Subject: Draft Revised Response to U.S. EPR Design Certification Application RAI No. 412, FSAR Ch. 3, Question 03.07.02-74
Sent Date: 3/30/2011 6:20:21 PM
Received Date: 3/30/2011 6:21:32 PM
From: WELLS Russell (AREVA)

Response to
Request for Additional Information No. 412 (4744), Revision 0
Question 03.07.02-74, Revision 2
5/28/2010

U.S. EPR Standard Design Certification
AREVA NP Inc.
Docket No. 52-020
SRP Section: 03.07.02 - Seismic System Analysis
Application Section: 03.07.02

Question 03.07.02-74:**RAI from Audit 4/26-30, 2010**

Figure 03.07.02-74-1—Impulsive and Convective Wall Pressure Distributions in the X direction

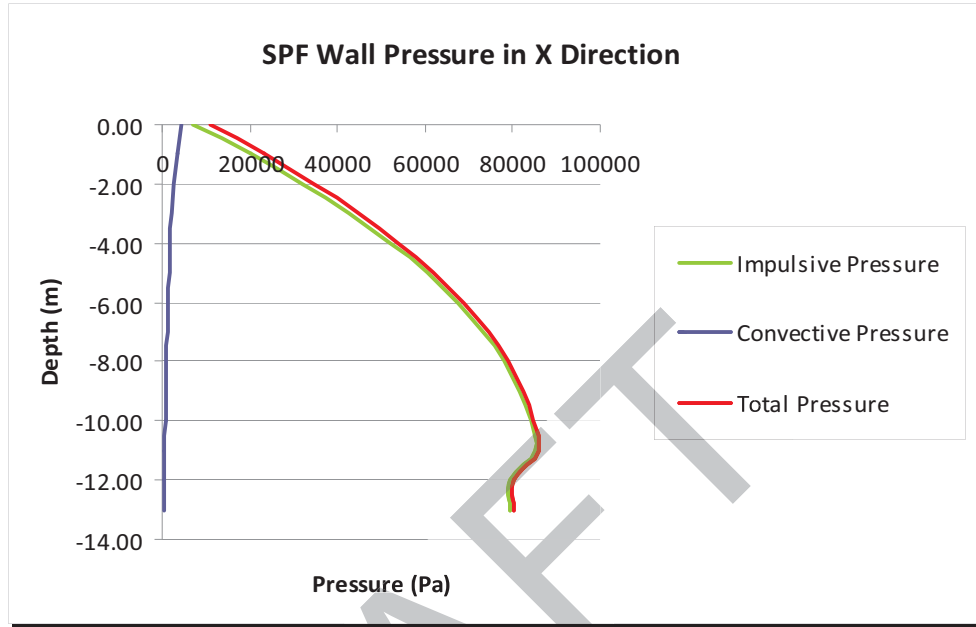
As part of the staff review of the SSI analysis of the Nuclear Island (NI) Common Basemat Structure, AREVA was asked to describe how seismic fluid-structure interaction was considered for those structures containing water in the NI (e.g., the IRWST, the spent fuel pool, etc.). AREVA stated that the entire mass of water is treated as a lumped mass which is added to the mass of the structure in which it is contained. In general the staff was satisfied with the method described but to ensure the analysis and design of the NI meets the requirements of GDC 2 for earthquake design and that the loads due to the seismic response of the water have been properly determined, the staff requests that AREVA provide the following information regarding fluid/structure interaction:

1. Describe how the contained water is modeled in the seismic analysis of the NI;
2. If convective loads are ignored, provide the basis for not considering them;
3. Justify the freeboard is sufficient to accommodate sloshing in the IRWST;
4. Provide the basis for water level assumptions when determining the effects of sloshing;
5. If they exist, describe the effect of sloshing loads; and,
6. Evaluate potential overspill in Spent Fuel Pool.

Figure 03.07.02-74-1 to Figure 03.07.02-74-3 show the hydrodynamic forces in a pool resulting from a horizontal earthquake, and represented by a combination of:

- Impulsive (P_0) and convective (P_1) forces acting on the pool walls.
- Impulsive (P_{b0}) and convective (P_{b1}) forces acting on the pool slab.

2. Convective loads are included in the hydrodynamic loads for the static FEM, as described in the Response to Item 1. Figure 03.07.02-74-1 and Figure 03.07.02-74-2 show the total hydrodynamic wall pressure distributions for SFP, including impulsive and convective pressures. The contribution from convective mode to the total hydrodynamic load is negligible for the ESWB pool, SFP and other NI pools, except for smaller or shallow pools such as the surge pool and in-containment refueling water storage tank (IRWST). Table 03.07.02-74-1 shows the wall frequencies and pressures for NI pools.

Figure 03.07.02-74-3—Hydrodynamic Pressure in Pool due to Horizontal Acceleration

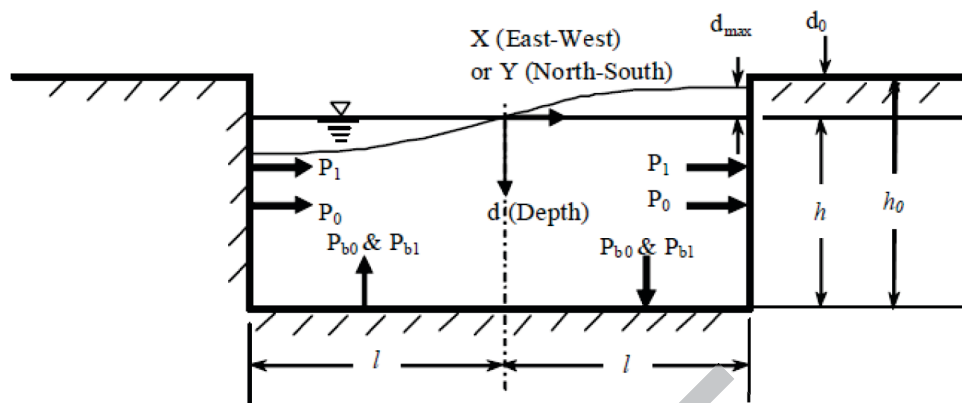
Provide the basis for not considering a seismic hydrodynamic impact load on the bottom of the spent fuel pool, the IRWST, or any other significant pool or tank in the NI, due to the response of the water from an earthquake acting in the vertical direction.

Convective force, P_1 , is created by a portion of the fluid moving as if it were a solid oscillating mass flexibly connected to the walls with a maximum sloshing height of d_{\max} , as shown in Figure 03.07.02-74-3. The natural frequency of sloshing fluid is determined by TID-7024, Equation 6.8:
